**PLAN COMMISSION / ZONING BOARD OF APPEALS  
AGENDA**

**Project:** Sparks Coffee Co. – New Construction  
**Meeting Type:** Public Hearing  
**Request:** Major change to PUD, Special Use Permits (4)  
**Location:** Hickory Creek Marketplace, Outlot 1E  
**Applicant:** Aliana Winkle  
**Prop. Owner:** Winkle R E Properties  
**Representative:** Applicant  
**Staff report by:** Christopher Gruba, Senior Planner

## **Major changes to plans since workshop**

SITE PLAN

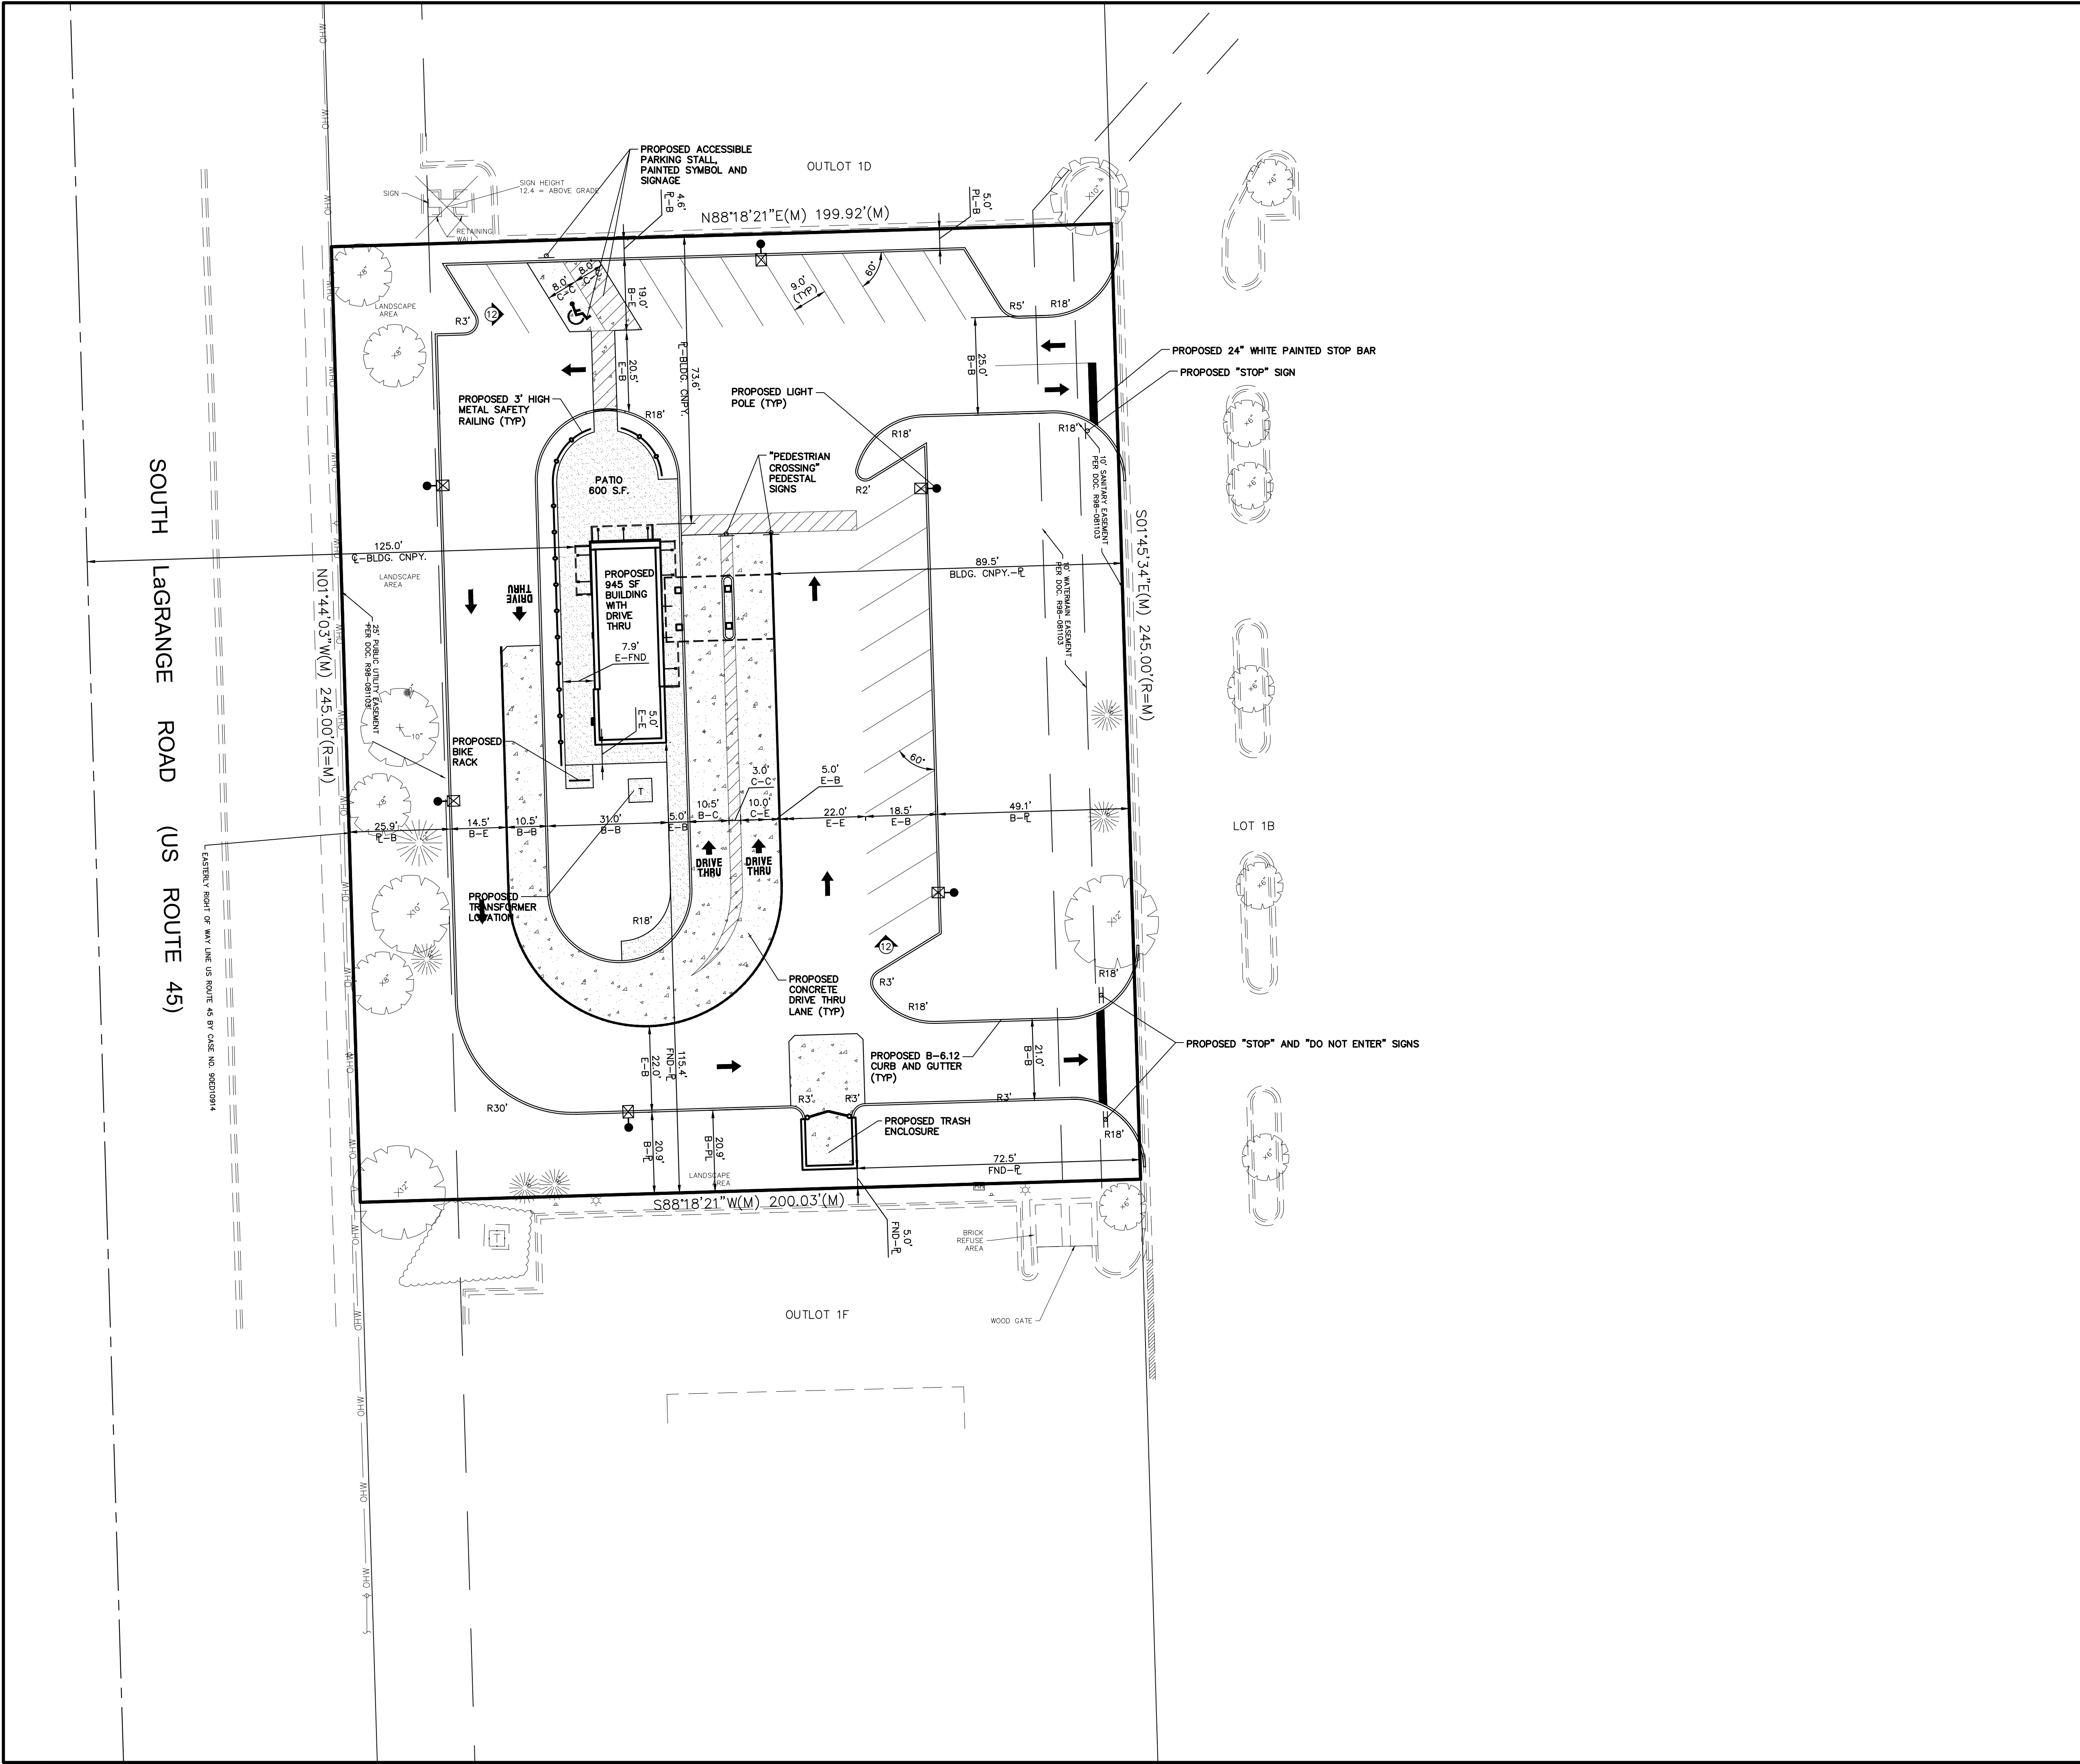
1. The drive-through canopy has been “flipped” so that it is now located on the east side of the building, facing toward Emagine Theater instead of Route 45. The direction of on-site traffic circulation remains the same, although vehicles would now enter the site at the northeast corner instead of the southeast corner.

2. The building is now set back 125’ from the centerline of Route 45 to the nearest part of the building, complying with the front setback requirement.

Accessory structures in the B-3 zone district must be set back at least 10' from any property line. The proposed trash enclosure is located 5' from the south side property line, requiring an exception. The proposed trash enclosure would be constructed of brick to match the building and complies with all other requirements listed in the Zoning Ordinance (height, gates).

4. Both Village staff and Robinson Engineering requested that the southern access drive to the property be made two-way instead of one-way exit only. As proposed, the southern exit-only driveway is 21’ wide,

giving it the appearance of a two-way drive, while being only slightly narrower than the southern two-way driveway, which is 25' wide. Staff believes that motorists will treat the 21' wide one-way as a two-way in practice anyway, as proposed. Lastly, if the southern driveway were converted to two-way, it should not affect the flow of traffic in the general counterclockwise motion.

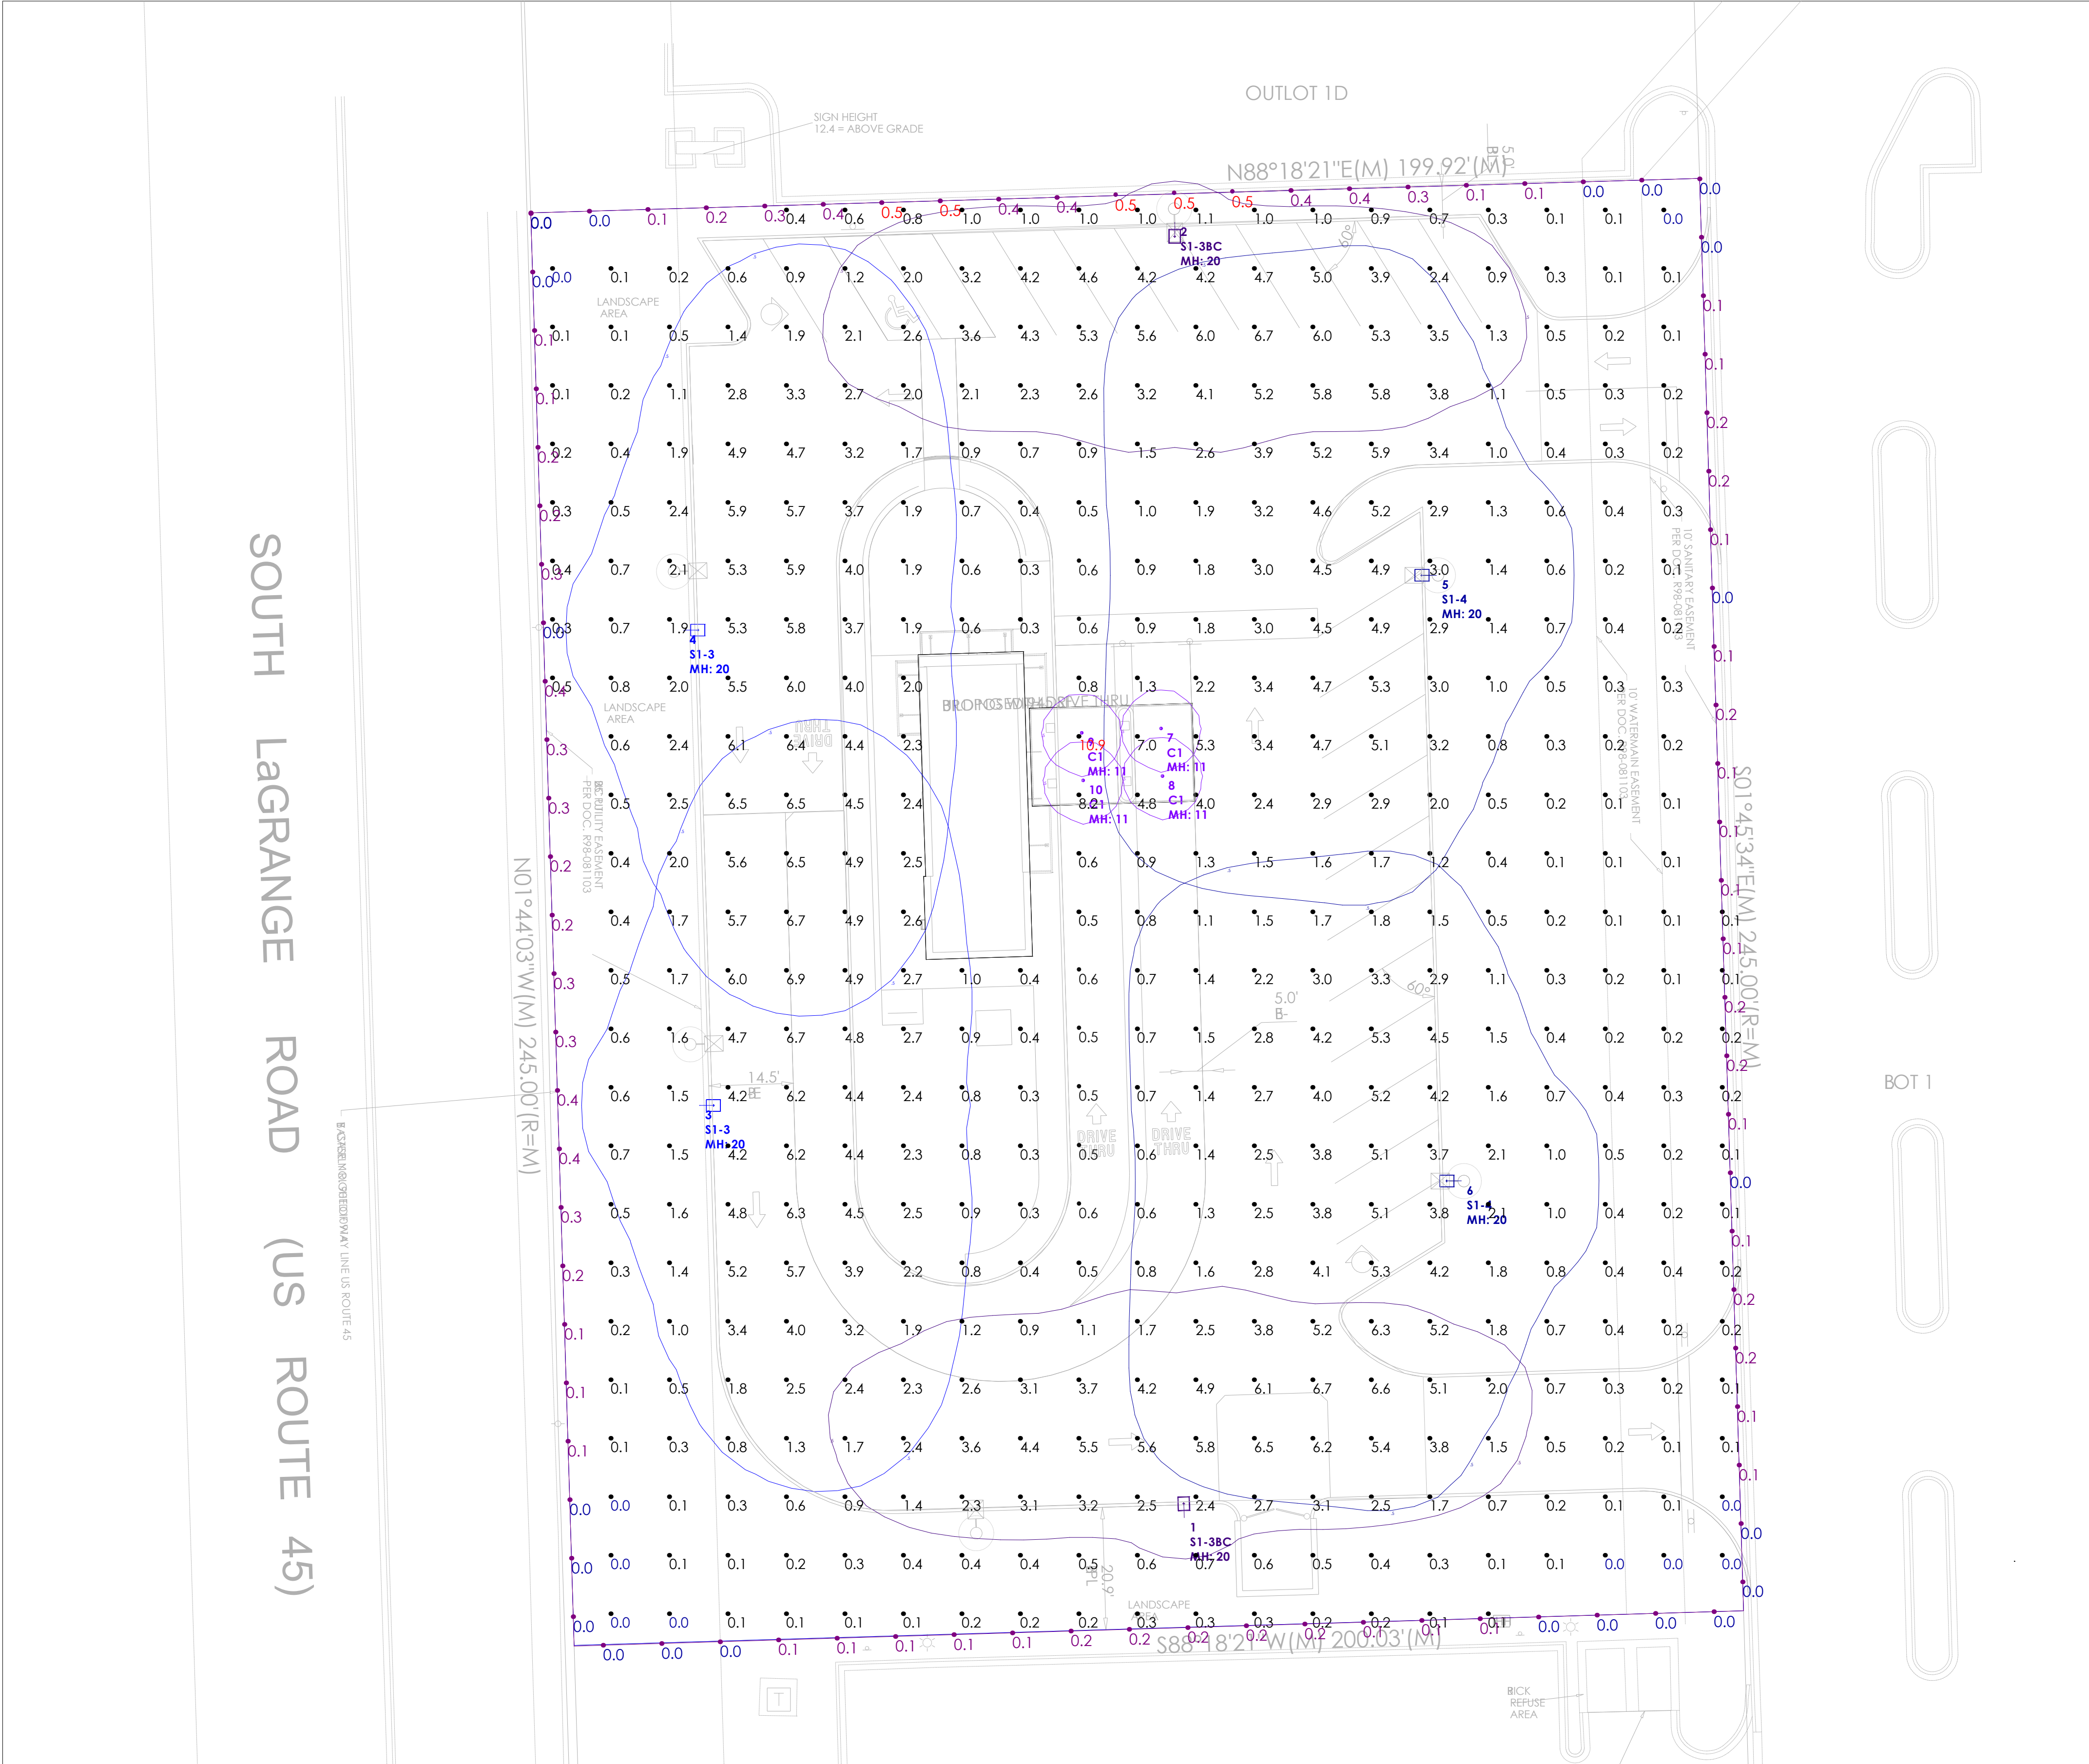
1. A Photometric Plan has been provided illustrating 6 new 20' tall light poles. The light levels comply with the levels permitted in the Zoning Ordinance.

2. The concrete bases of the light poles should match the other light pole bases in Hickory Creek Marketplace, and a rendering of this has been included on the Photometric Plan.

3. The existing light pole fixtures within Hickory Creek Marketplace are painted white, with a "shoebox" style light fixture. It's unlikely that the applicant could procure light fixtures that exactly match the existing light pole fixtures. However, staff recommends that the proposed light poles be painted white to match the rest of the PUD. The white color has been noted on the Photometric Plan.

4. The maximum height of light poles in the B-3 zone district is 25'. The proposed light poles would be 20' tall, meeting this requirement.
5. In addition to the six light poles, there would also be four recessed can lights beneath the drive-through canopy.
